GTR24 Temperature limits for non-gray cast iron rotors

28.Sept.2023

UNECE GTR24 Temperature Limits vs. advanced Disc results

GTR24 Temperature limits Vs. Advanced disc results. Temperature Results of variable cooling airflow (950→300).

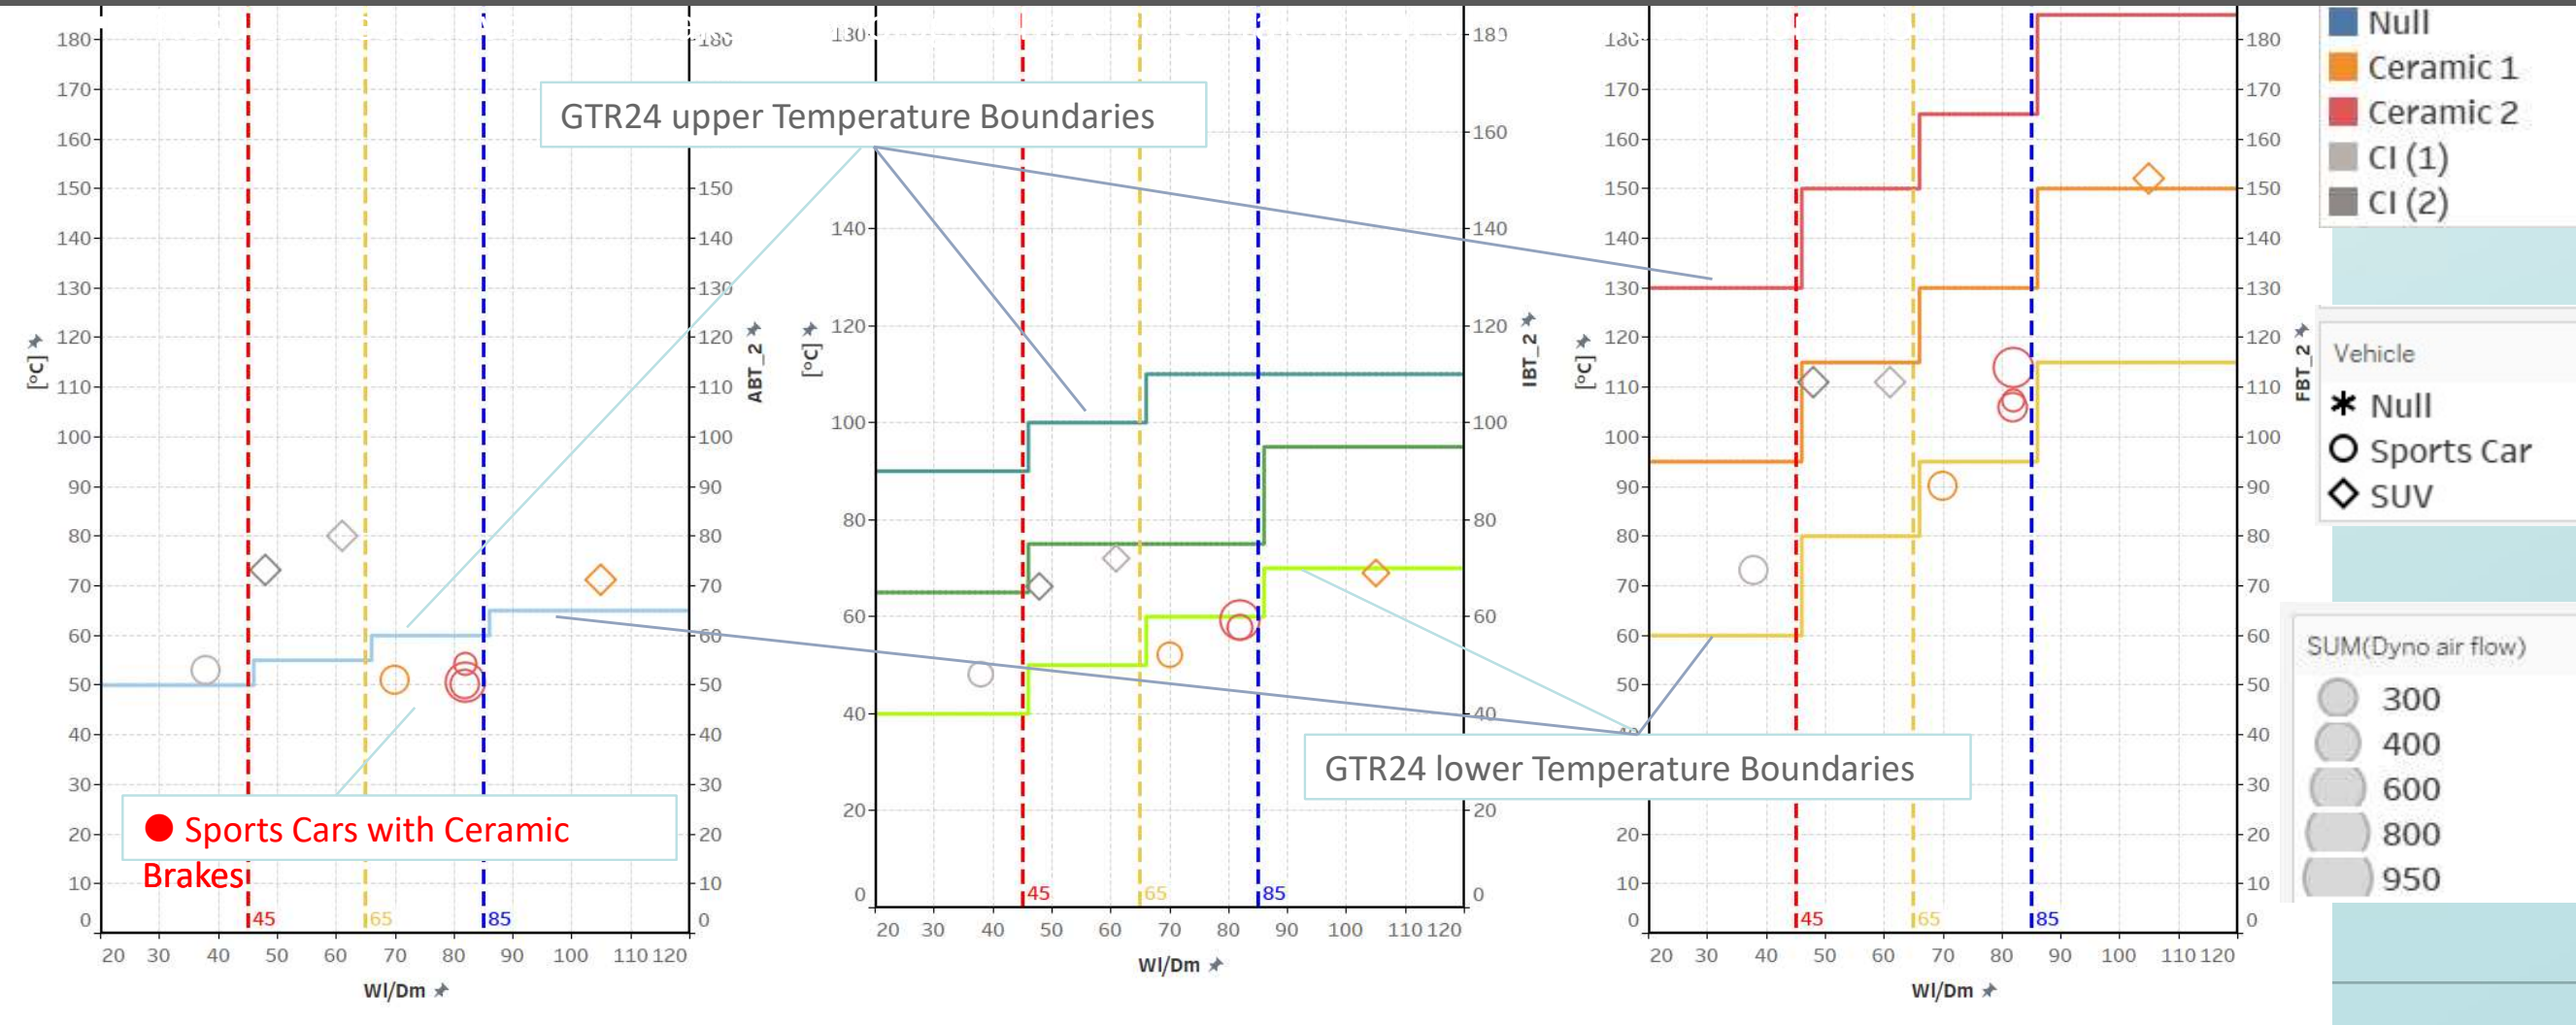
- Even if the cooling air flow is set to a minimum, the temperatures (specifically ABT) specified in table 10.2 cannot be maintained.
- Result: Currently, CSIC brakes and further advanced brakes unable to be homologated according to GTR24.
- Risk: These advanced brake technologies have to be taken out of the solution portfolio .

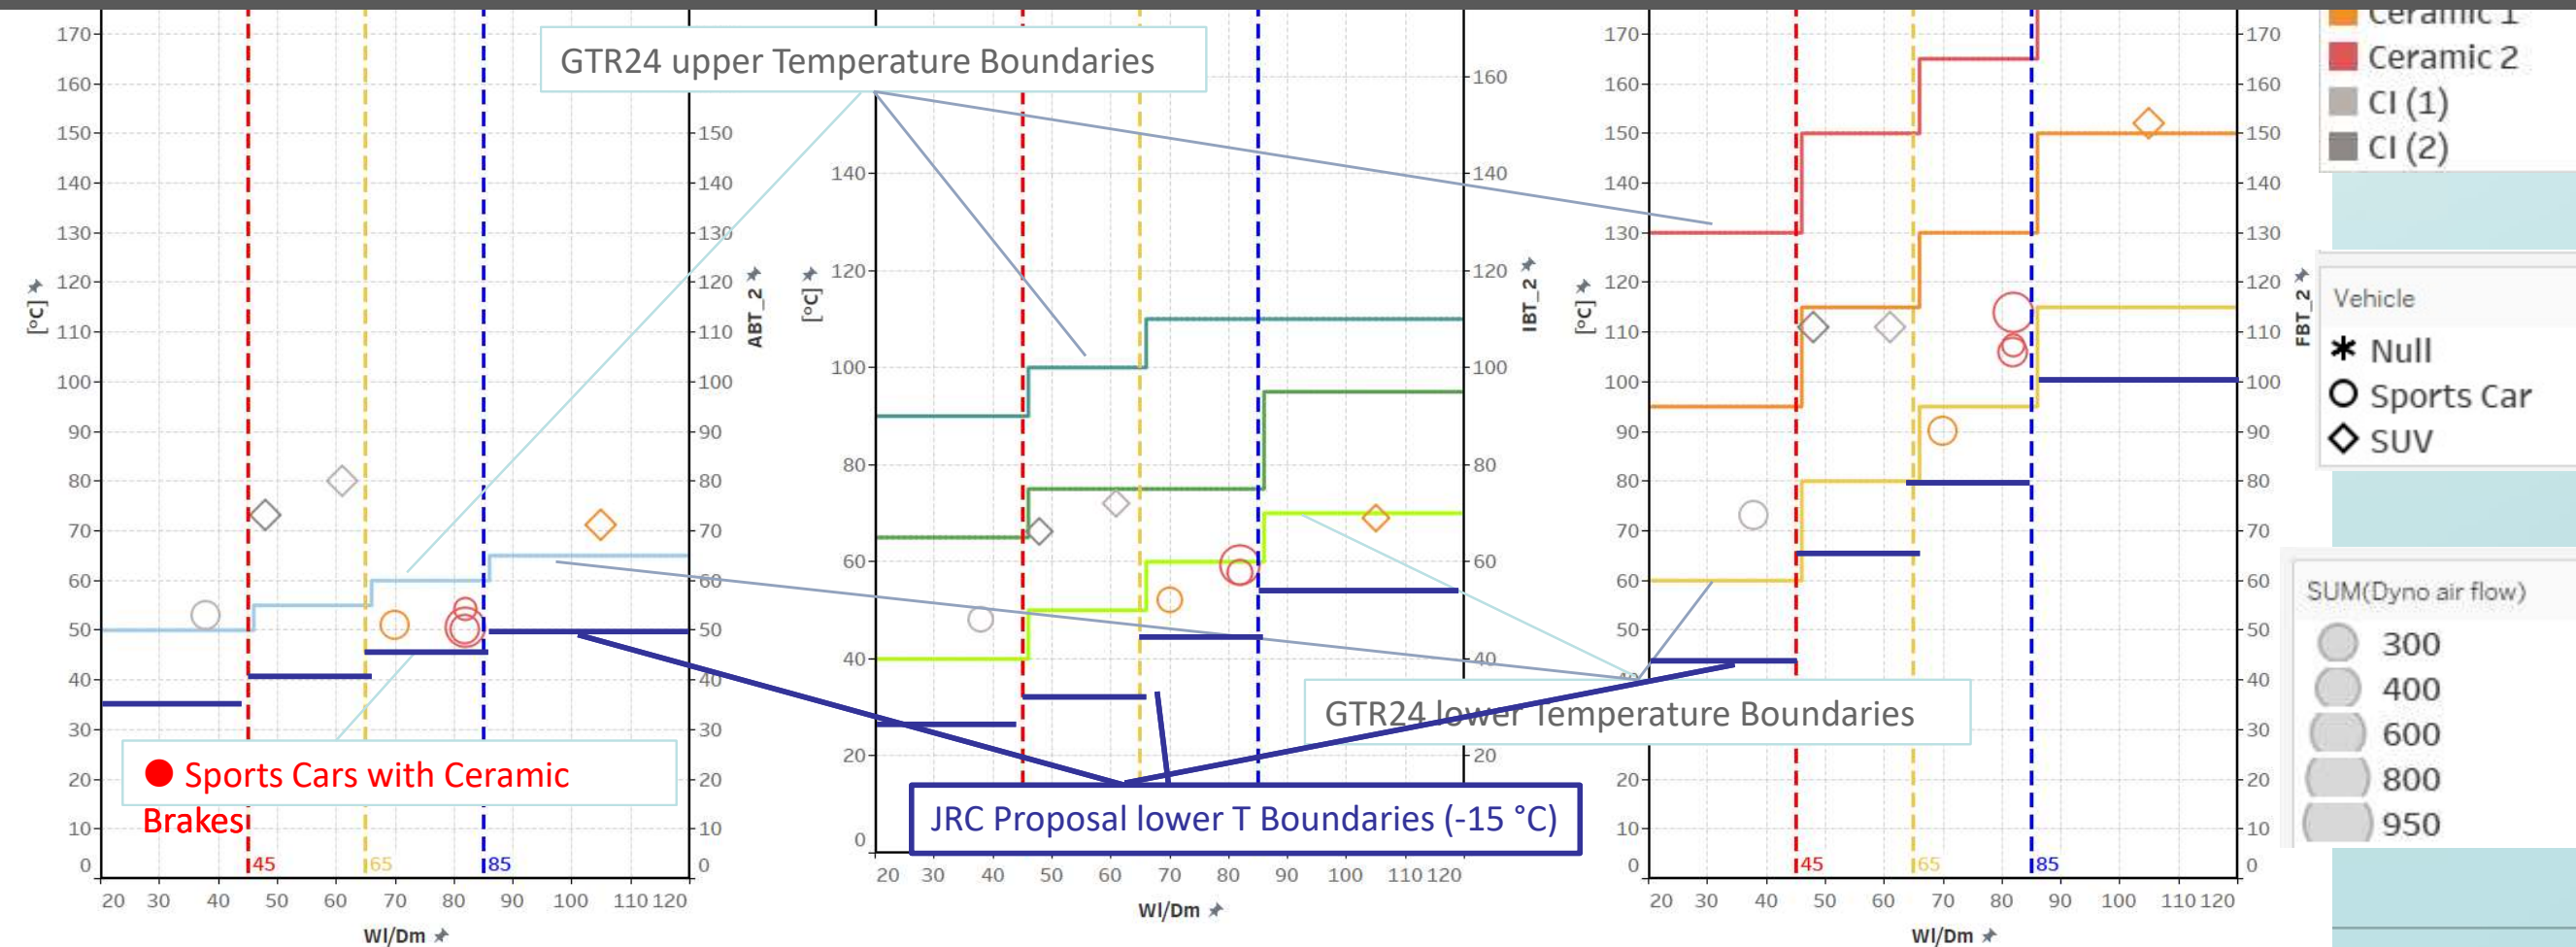
- Even if the cooling air flow is set to a minimum, the temperatures (specifically ABT) specified in table 10.2 cannot be maintained.
- Result: Currently, CSIC brakes and further advanced brakes unable to be homologated according to GTR24.

- JRC proposal:

“ Introduction in the GTR of an asterisk below the temperatures Table stating that "For CCGI discs, the defined temperature regimes at the lower end may be relaxed by 15C. This applies to all 4 WL/DM groups".
